PRP Comments
16.06.23
Drawing Review 02

Note: These comments are solely in the capacity of Passivhaus Designer, with no design responsibility.

Ashley Road Depot

Roof Details - SMJ Flat Roof

1 | Projecting Balcony - Section
1 : 10

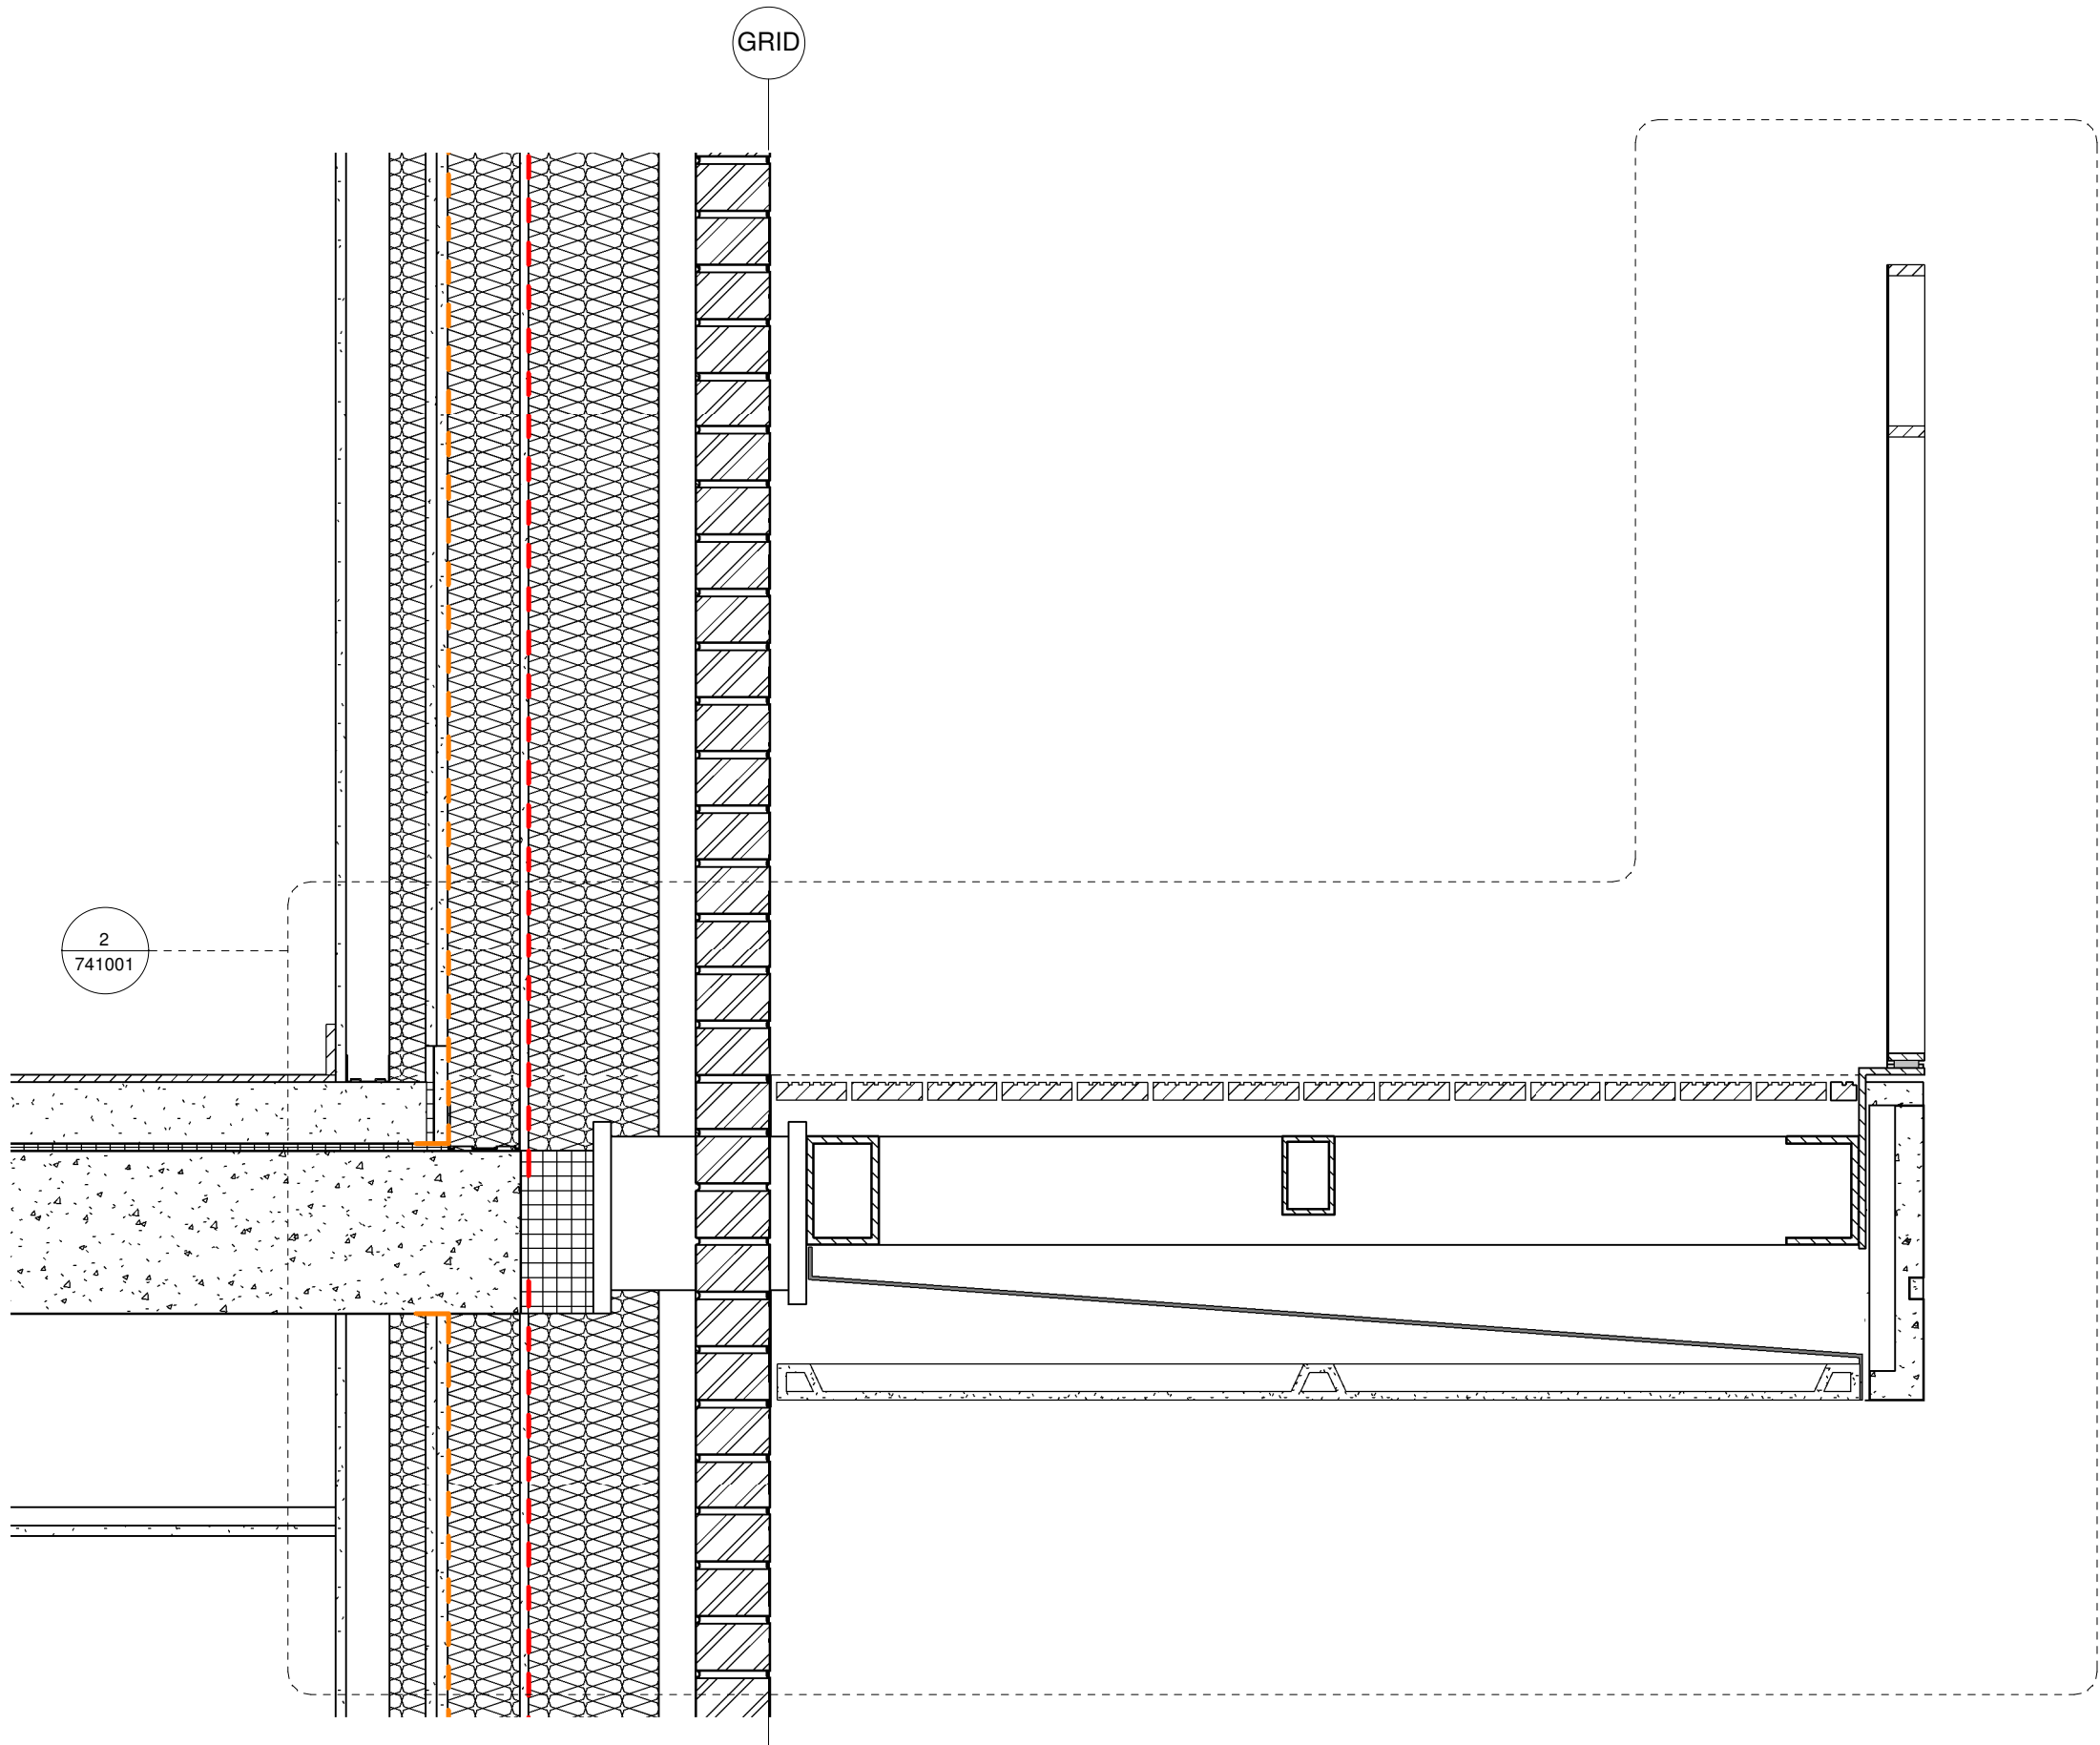
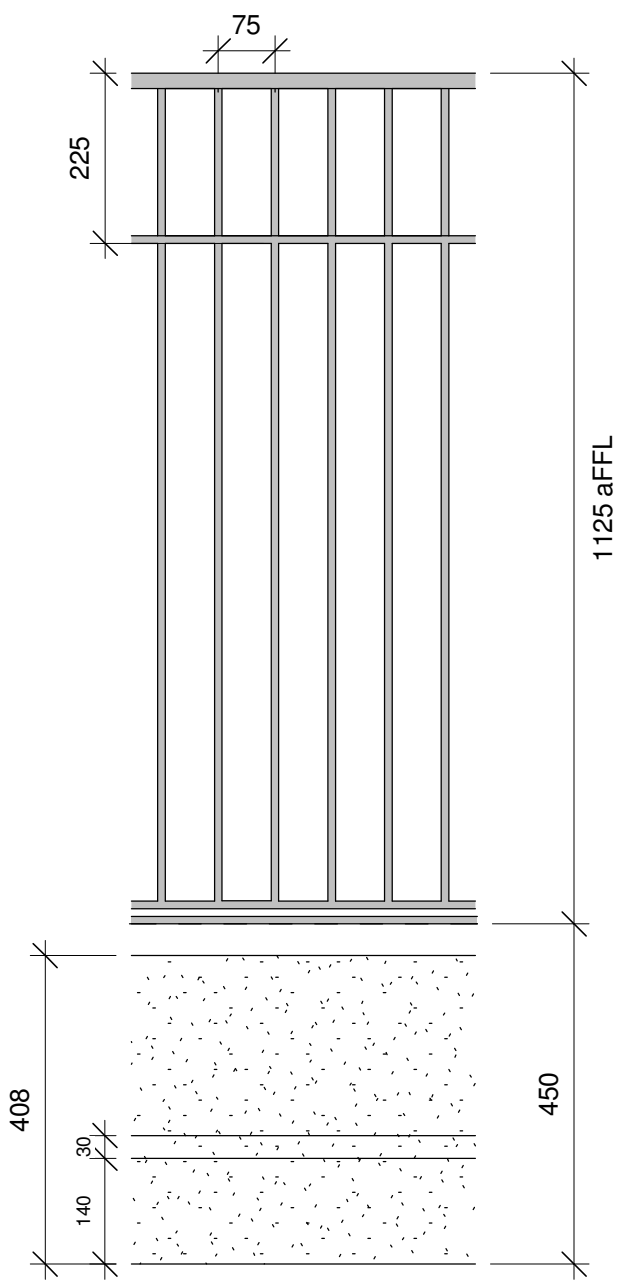
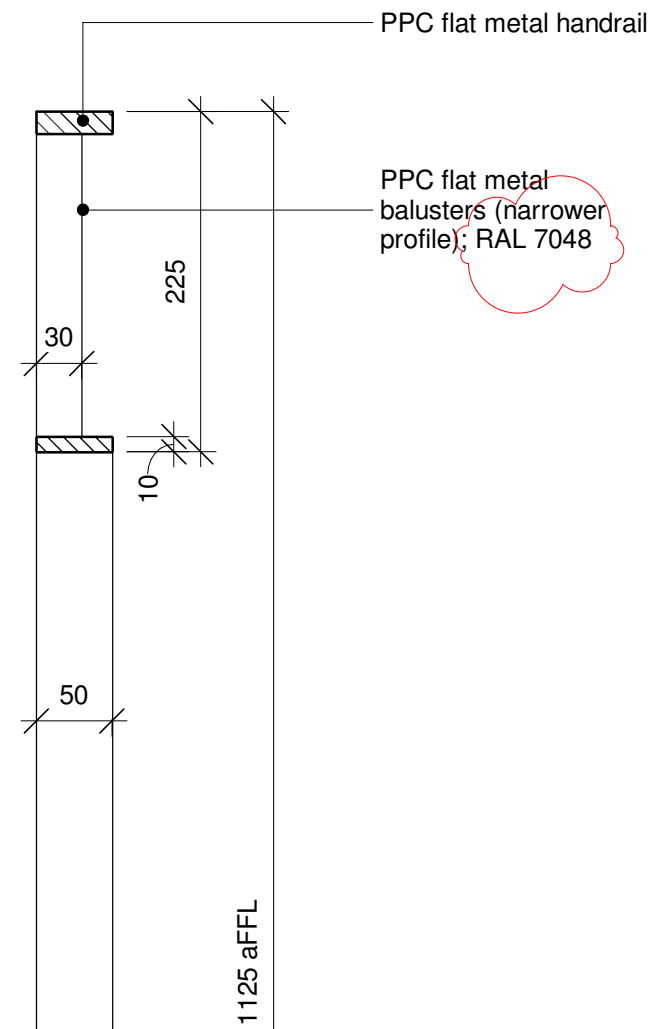
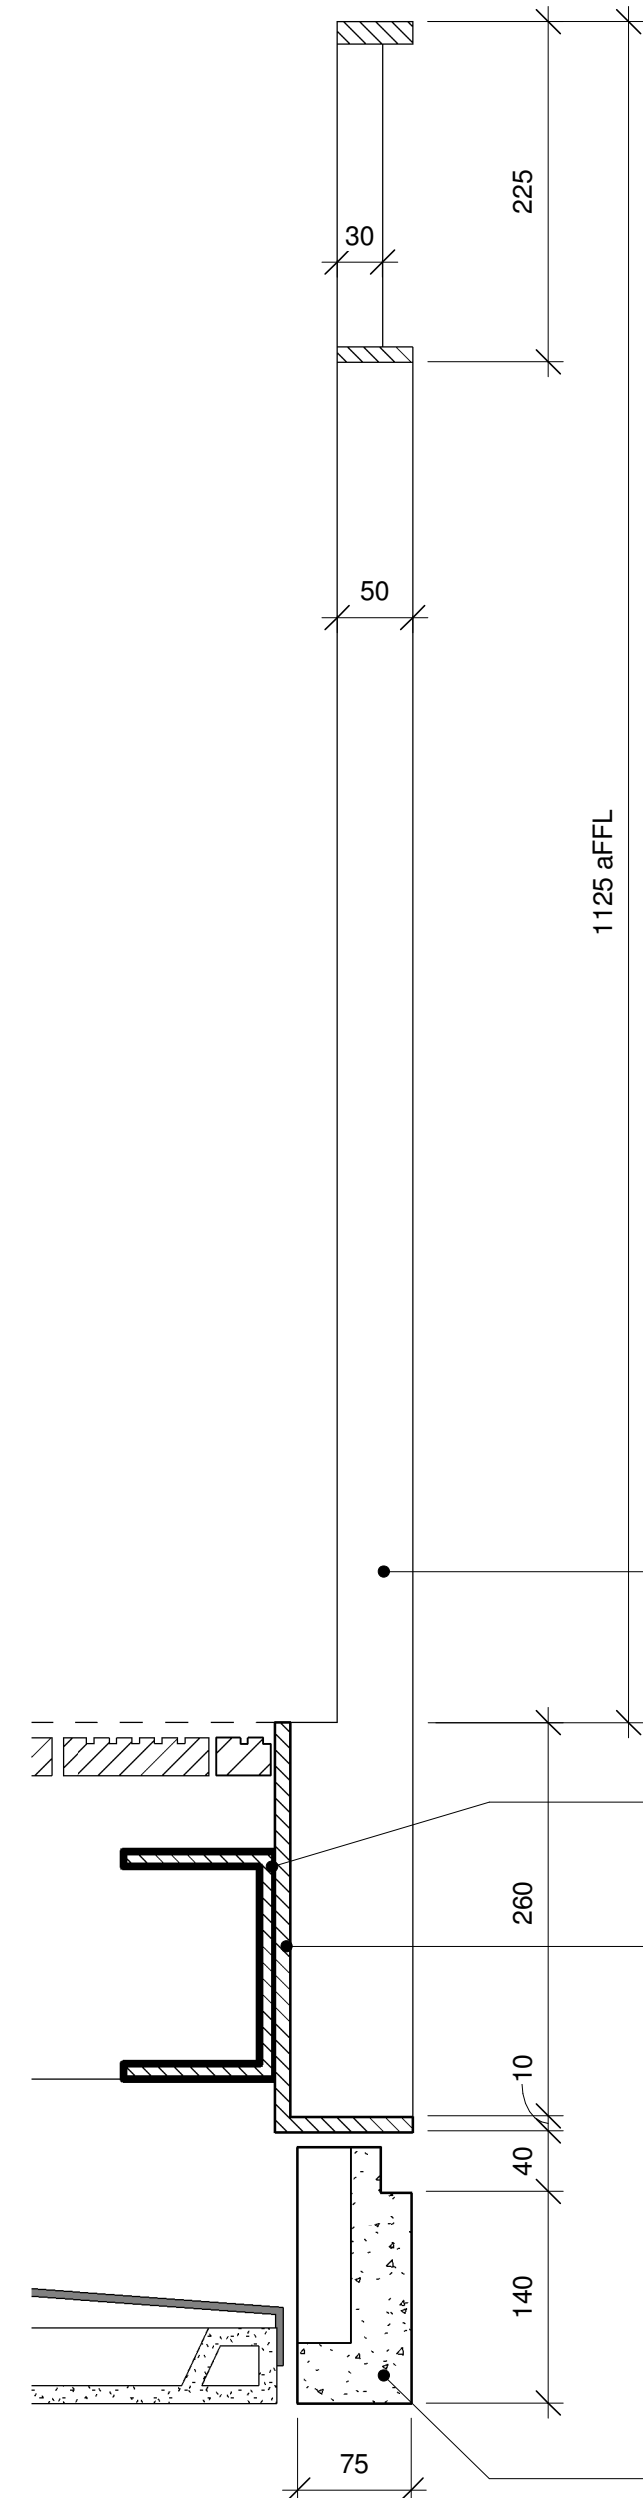
Windows: These should not be greater than **0.8 W/(m²K)**. This is what you have referenced below, so this is a comfortable position to be in. Windows should also have an insulated frame, be triple glazed, sit within the thermal envelope line and not break the airtightness line. A Ug-value should be 0.5 W/(m²K).

Dwelling access doors from outside: If these contain glass, the u-value must be **0.8 W/(m²K)**. External doors (without glazing) must not have a greater u-value than **1.0 W/(m²K)**. There should be no letterboxes in the doors. Doors should be insulated with airtightness properties, aligning with the wall's thermal envelope line and not break the airtightness line.

Curtain walling screens: These should not be greater than **0.8 W/(m²K)**.

Doors within curtain walling if different to the screens themselves: These should not be greater than **0.8 W/(m²K)**.

Ancillary doors to heated and unheated spaces: This is under review regarding the lift core, stair core and circulation spaces. Doors within the dwellings and overall thermal envelope do not necessarily need to achieve a specific u-value, however, to align with MVHR (Mechanical Ventilation Heat Recovery) and ventilation systems a 10mm undercut is required beneath internal doors of dwellings. Doors into unheated spaces will require to meet the same as an external door, if they sit within the thermal envelope line, they would be treated with the same thermal properties and airtightness requirements as an external door. The exact approach for this within Ashley Road differs across the three blocks/phases and is still under review.
